HARRISON SCHOOL

HARRISON PARK

CITY OF RIVERSIDE

IRRIGATION PLAN

sheet no. SP-1

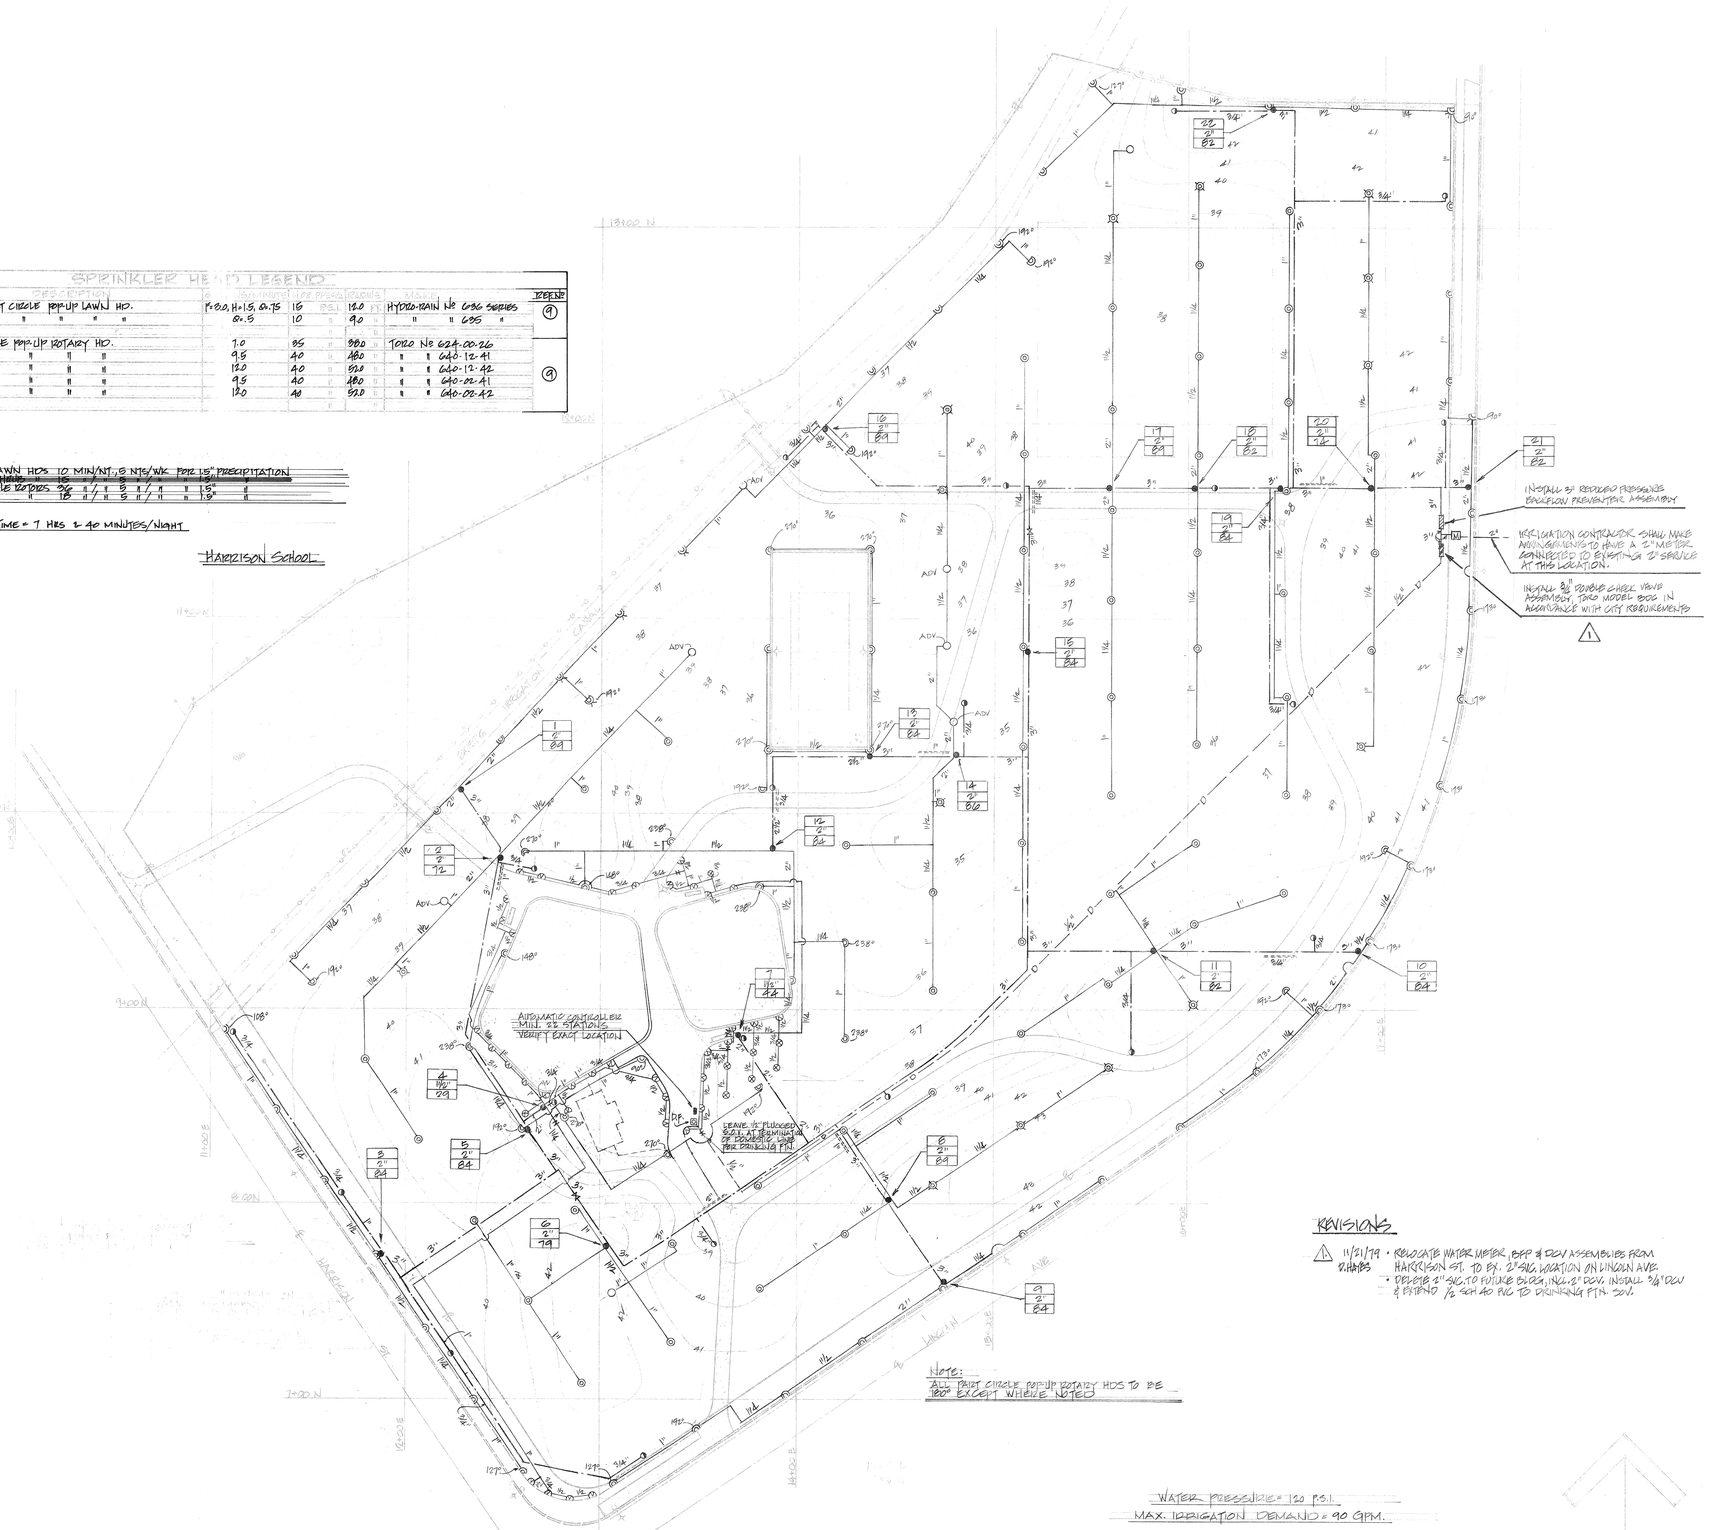
~~OPERATE POP-UP LAWN HDS 10 MIN/NT., 5 NTS/WK FOR 1.5" PRECIPITATION~~

~~" " STREAM SHRUB " 15 " 5 " / " " 1.5" "~~

~~" FULL CIRCLE ROTORS 36 " / " 5 " / " " 1.5" "~~

~~" PART " " 18 " / " 5 " / " " 1.5" "~~

1. 11/21/79 D.HAYES • RELOCATE WATER METER, BFP & DCV ASSEMBLIES FROM HARRISON ST. TO EX. 2" SVC. LOCATION ON LINCOLN AVE.
   • DELETE 2" SVC. TO FUTURE BLDG, INCL. 2" DCV. INSTALL 3/4" DCV & EXTEND 1/2 SCH 40 PVC TO DRINKING FTN. SOV.

TOTAL WATERING TIME = 7 HRS & 40 MINUTES/NIGHT
